BRKDD26HDM Datasheet
Product Revision: Rev B

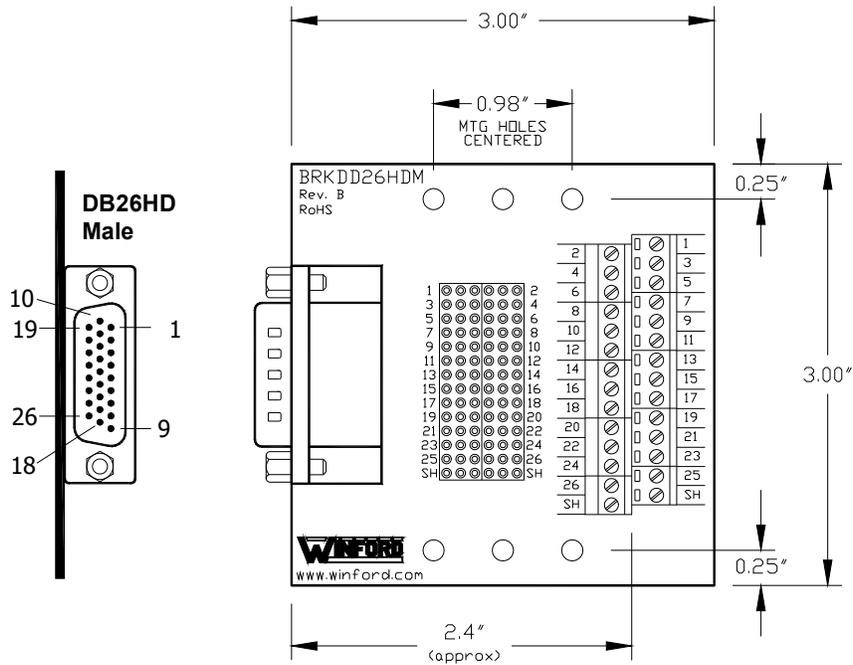
Date	Description
01/20/2011	Rev B Changes: <ul style="list-style-type: none"><li data-bbox="337 275 1175 300">• Brought DB26HD Shield/Shell connection out to new solder pads and screw terminals<li data-bbox="337 310 781 336">• Enlarged board by 0.1" (0.05" on each side)<li data-bbox="337 346 992 371">• Shifted mounting holes / DIN clips by the same 0.05" on each side<li data-bbox="337 382 854 407">• Larger silkscreen number labels by screw terminals
